RE: Shoot Point Blank Range and Gun Shop  
Alternative Standard Request Letter  
1915 South Stemmons Freeway – Former Bassett Furniture Store

**DEVELOPMENT PLAN FOR**  
**POINT BLANK RANGES**  
 CORPORATE SQUARE  
 LOT 6R-1, BLOCK A  
 2.26 ACRES  
 ZONED "LI"

SHEET TITLE:  
 LANDSCAPE PLAN  
 PROJECT: ORIGINAL ISSUE: 12-27-16

**1 LANDSCAPE PLAN**  
 SCALE: 1" = 20'-0"

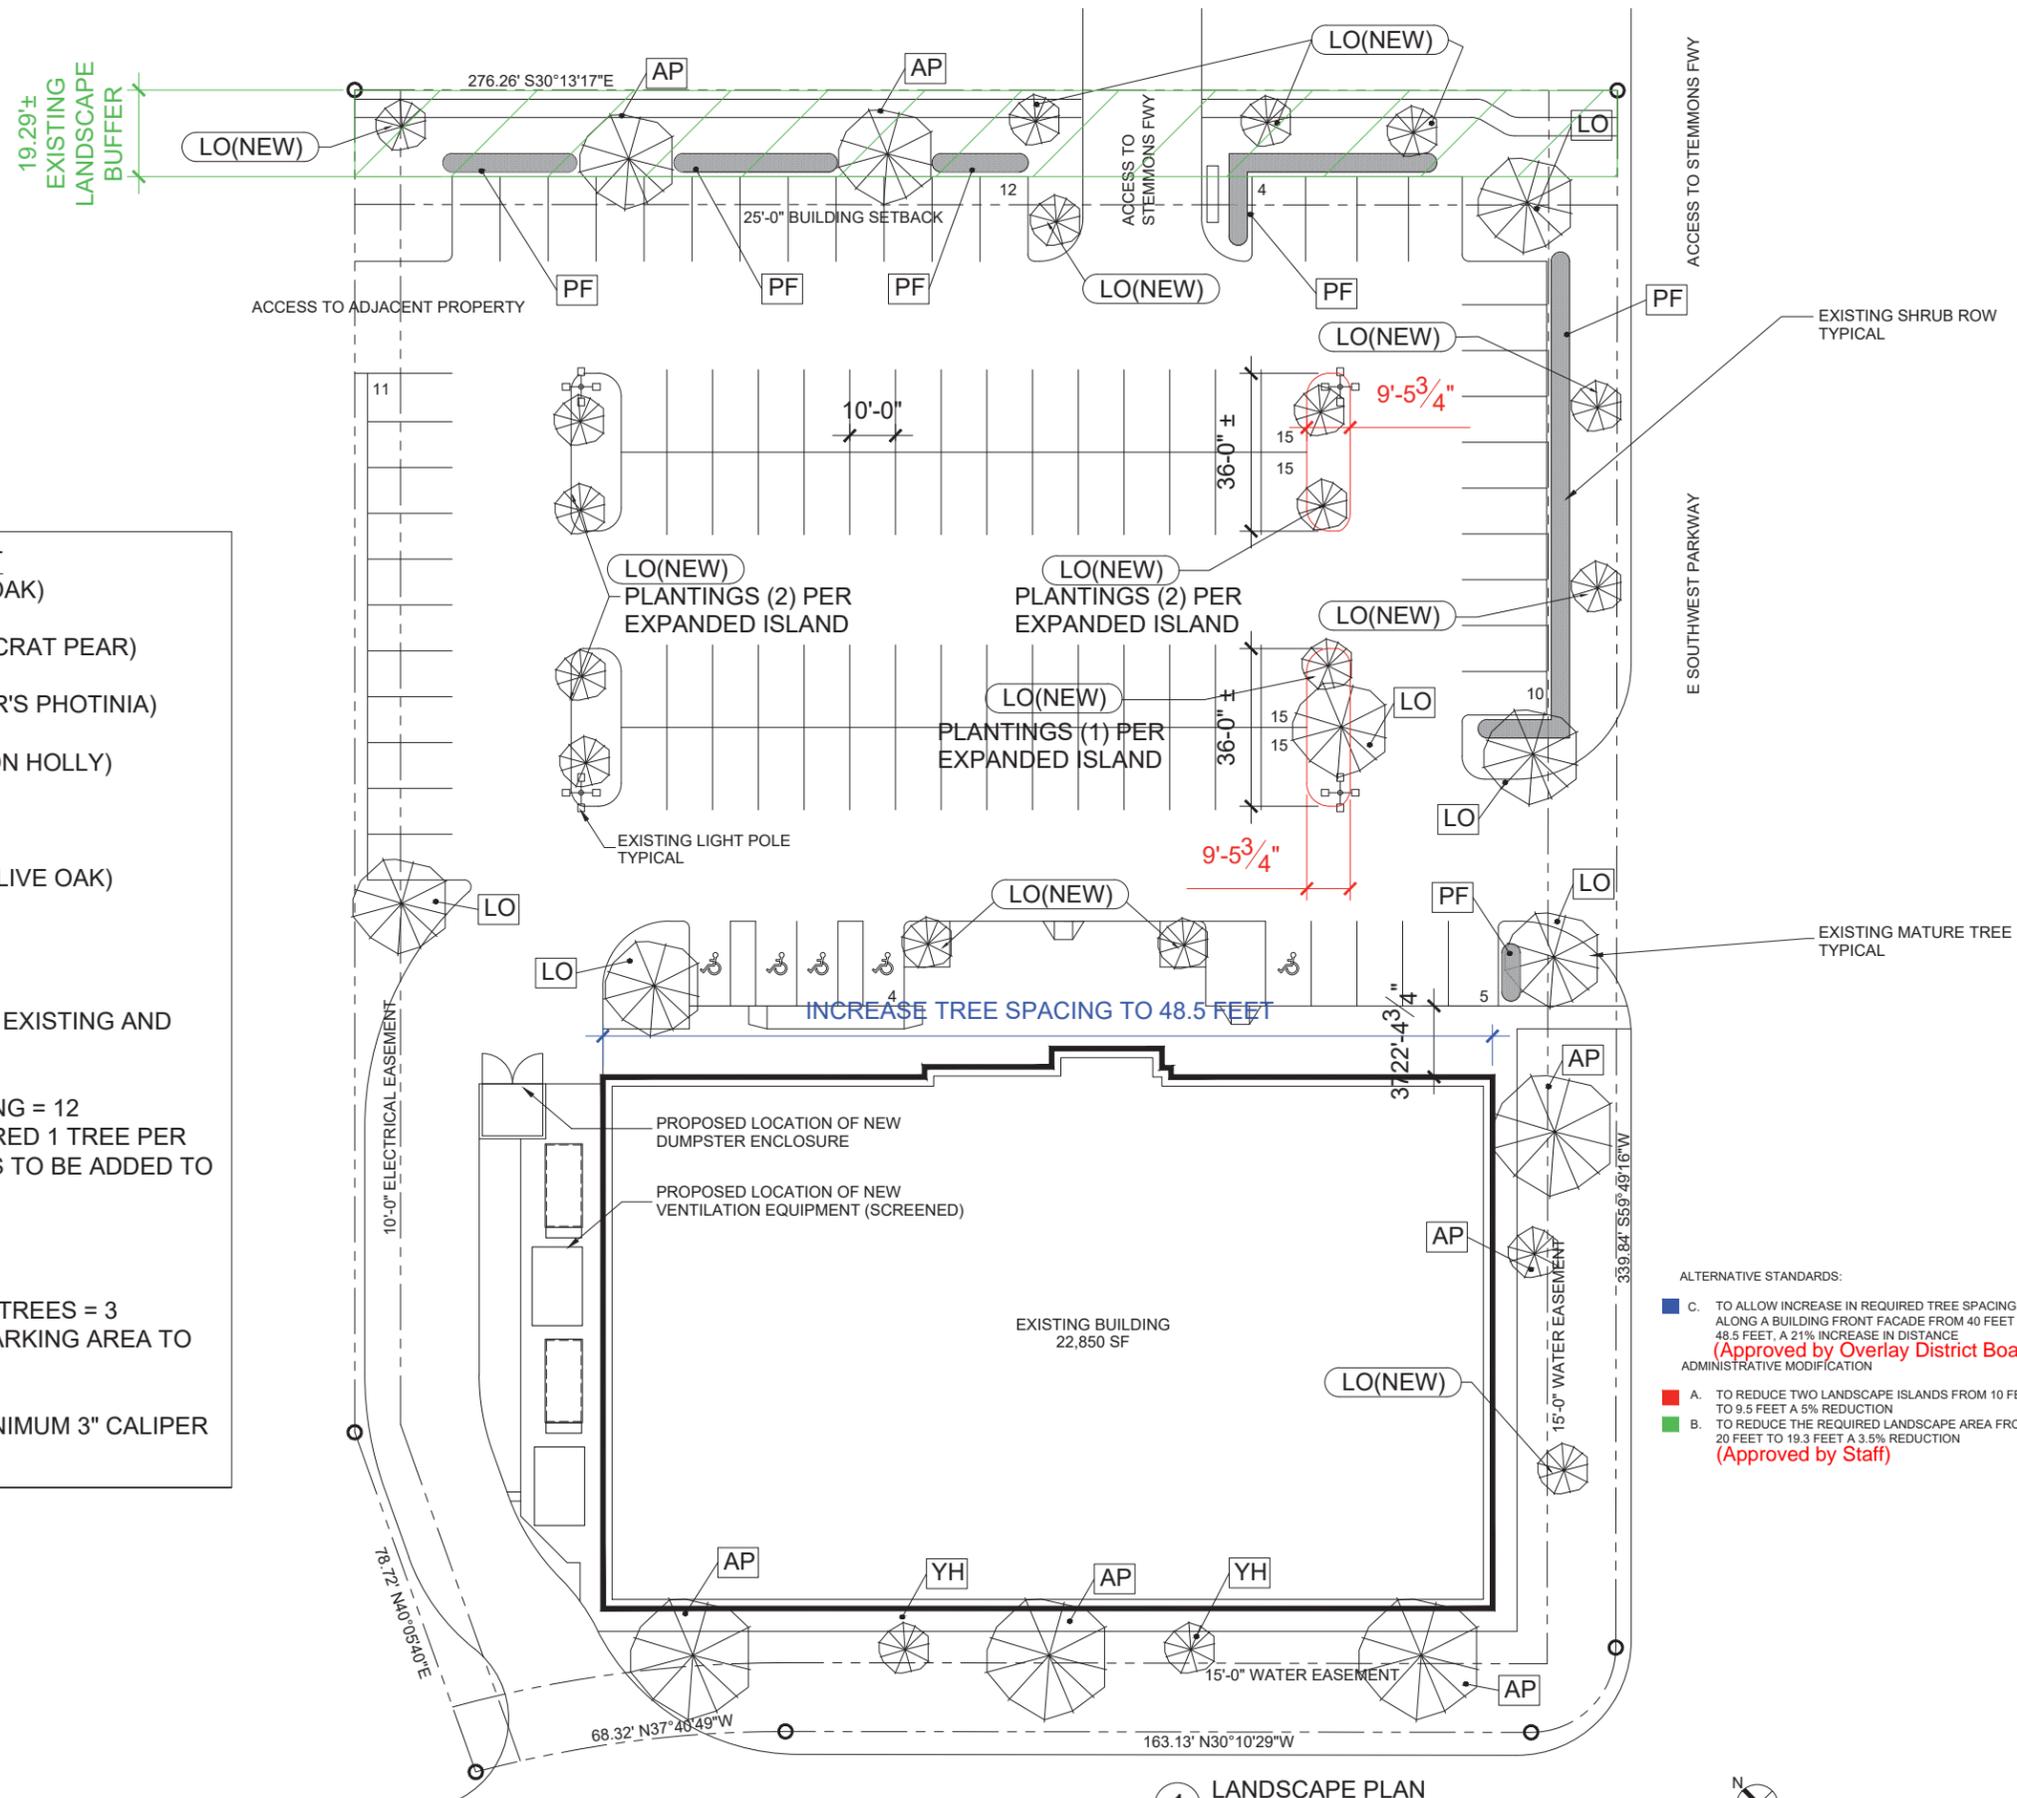
- ALTERNATIVE STANDARDS:**
- C. TO ALLOW INCREASE IN REQUIRED TREE SPACING ALONG A BUILDING FRONT FACADE FROM 40 FEET TO 48.5 FEET, A 21% INCREASE IN DISTANCE  
 (Approved by Overlay District Board)  
 ADMINISTRATIVE MODIFICATION
  - A. TO REDUCE TWO LANDSCAPE ISLANDS FROM 10 FEET TO 9.5 FEET A 5% REDUCTION
  - B. TO REDUCE THE REQUIRED LANDSCAPE AREA FROM 20 FEET TO 19.3 FEET A 3.5% REDUCTION  
 (Approved by Staff)
